Analysis and Review

North Woods Master Plan Subdivision

Prepared for the
Residents of Henry Case Way

Prepared by
Ashley V. Sweet
Professional Planning and Land Use Consultant
May 25, 2020

Figure 4: Future Sewer Service Area

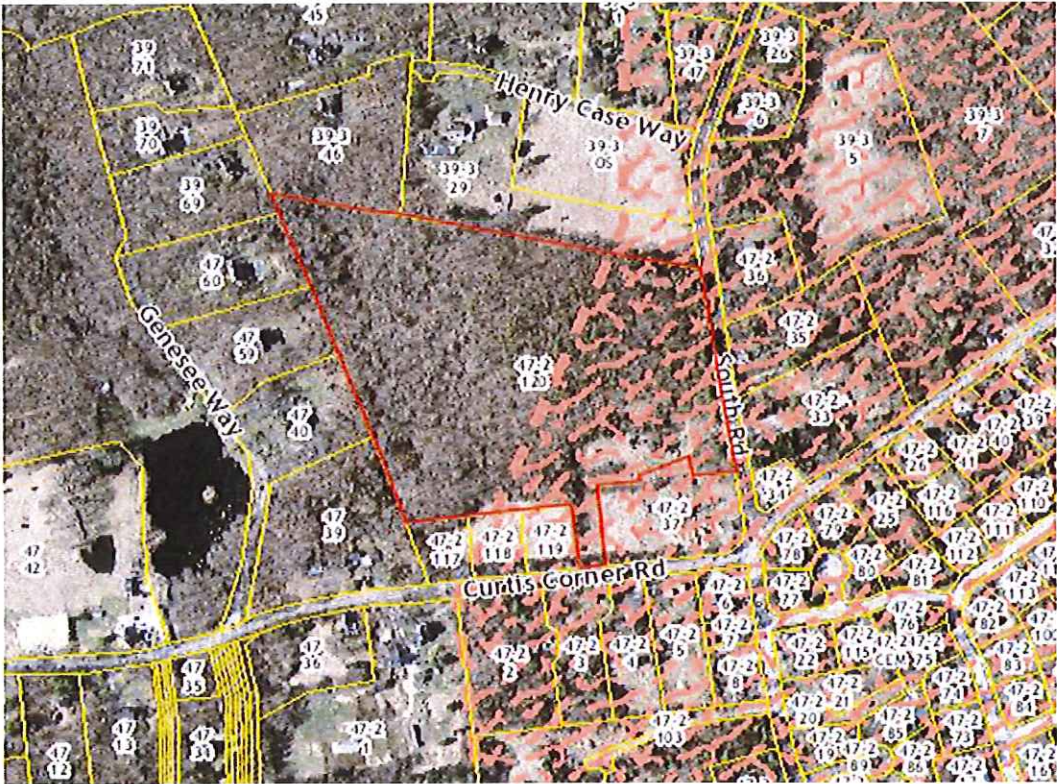
Figure 4 on the following page shows the future sewer service area with relationship to the subject parcel. Approximately 30 – 40 percent of the subject parcel falls within the future sewer service area identified on the Town's GIS online mapping tool. The staff report provided for this application identifies that *"despite being located within the Future Sewer Service Area (FSSA), and after an extensive soil analysis, the Public Services Director has agreed to waive the requirement to connect to the municipal sewer system provided the applicant restricts the density of this development to fourteen (14) market rate plus any affordable units required."* No soil extensive soil analysis, nor letter or notice from the Public Services Director was supplied as part of the materials received with our request for a copy of the information on file. We would respectfully request a copy of the soil evaluation and/or analysis that was conducted that led to the determination that this proposed subdivision was not required to tie into the sewer.

The yield plan for the site alleges that 19 lots could be built under conventional subdivision design. The currently proposed design, under the FDRP regulations, yields 16 lots with 17 units (one duplex). The difference between the yield and this proposal is 2 units. We are requesting access to the analysis that was conducted that led to the determination that sewer connections are not necessary.

At northern property boundary facing south (both photos)

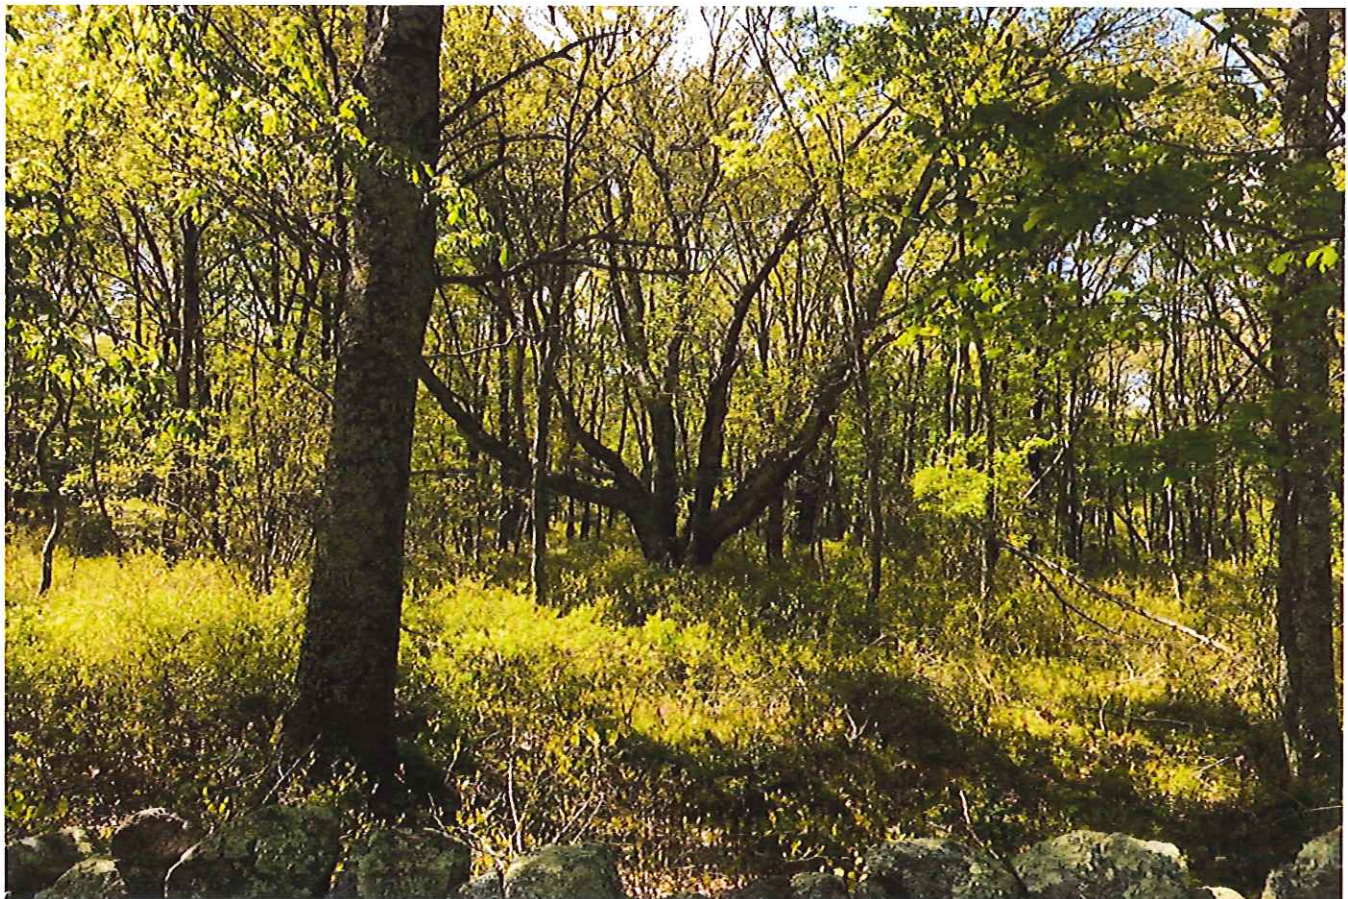
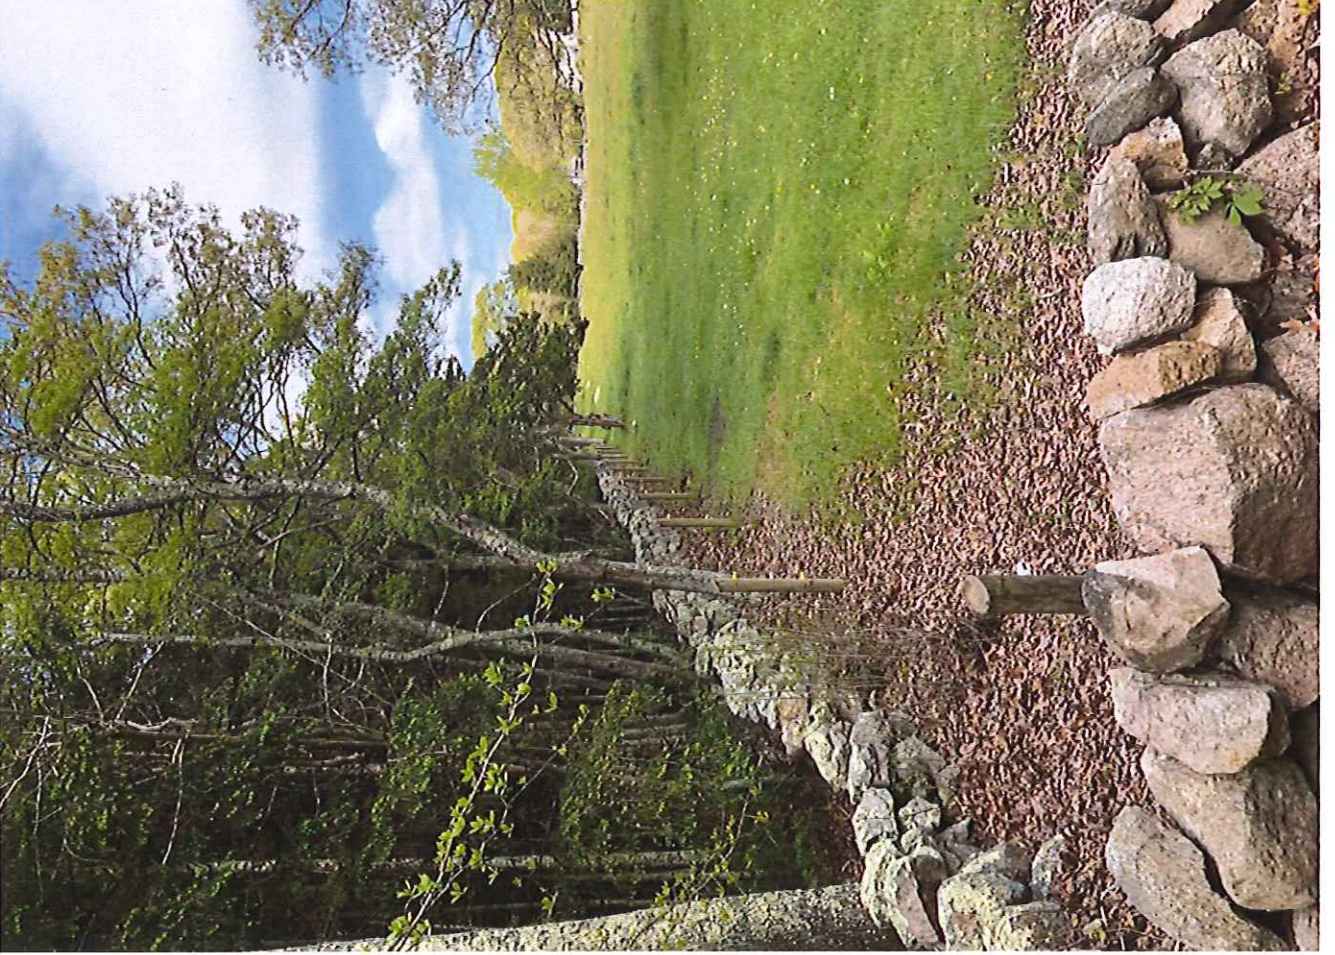
Appendix A of this report provides a visual assessment of the northern property boundary of the subject parcel with the Henry Case Way subdivision. The area currently designated as the 50' perimeter buffer consists of hardwood trees and little to no undergrowth. This will not provide adequate buffering. The entire southern boundary area of A.P. 39-3, Lot 29 is utilized by the animals that reside on that lot. Their designated living area direct abuts the 50' designated buffer area and as proposed, that buffer area is

insufficient to protect their health and habitat. Additional buffering is required along this area for both the human and animal residents of Henry Case Way. There should be a minimum of 100' buffer provided along that property line and the buffer area should have supplemental plantings of low growth buffer materials to provide adequate visual screening.

**Photos show buffer area contains mostly tall trees and
little to no undergrowth for proper visual buffering**
